Submissions Report

Blind Creek Solar Farm

November 2022

Project Number: 22-319

Figure 4-14 Existing screening around the sand quarry

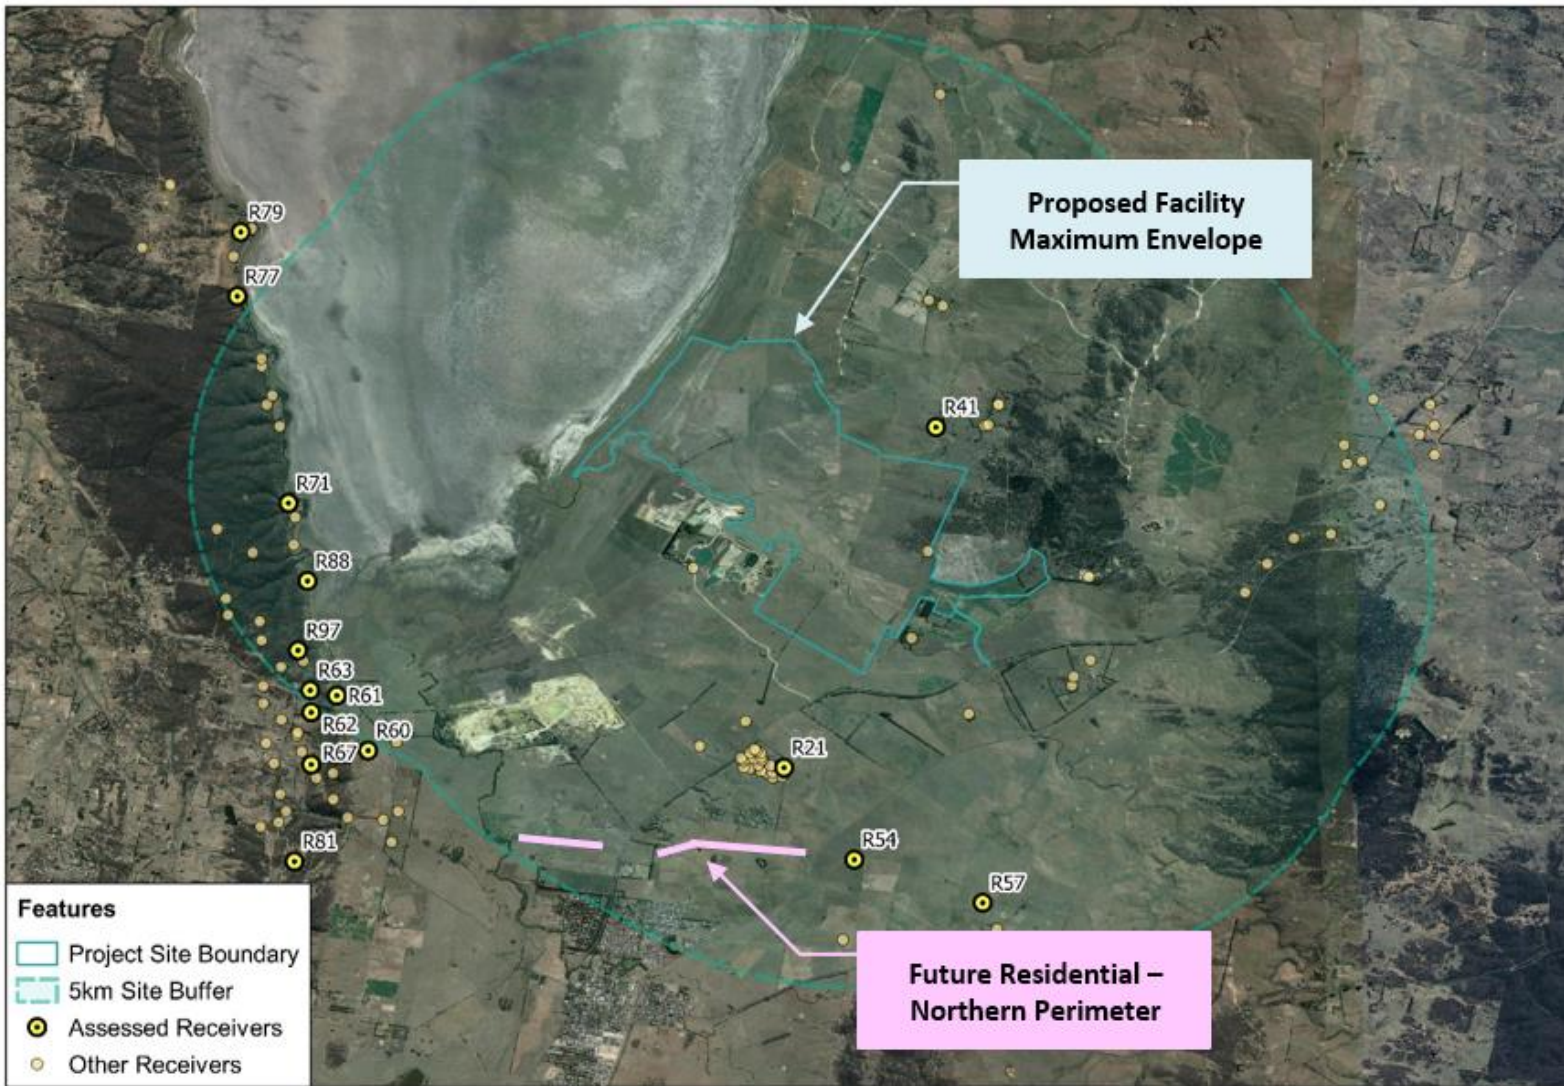
Issue	Detail of issue	Applicant response
	 Figure 4-13 Views towards the Project from the proposed Bungendore Estate	A VP was not established west of Tarago Road near the Potential

Issue	Detail of issue	Applicant response
		Investigation Area. However, existing screening in the form of vegetation along property fence lines and around the sand quarry would likely filter view of the Project as shown in Figure 4-14 below. View towards the Site with intervening vegetation associated with Bungendore Sands Quarry. Refer to figure below.
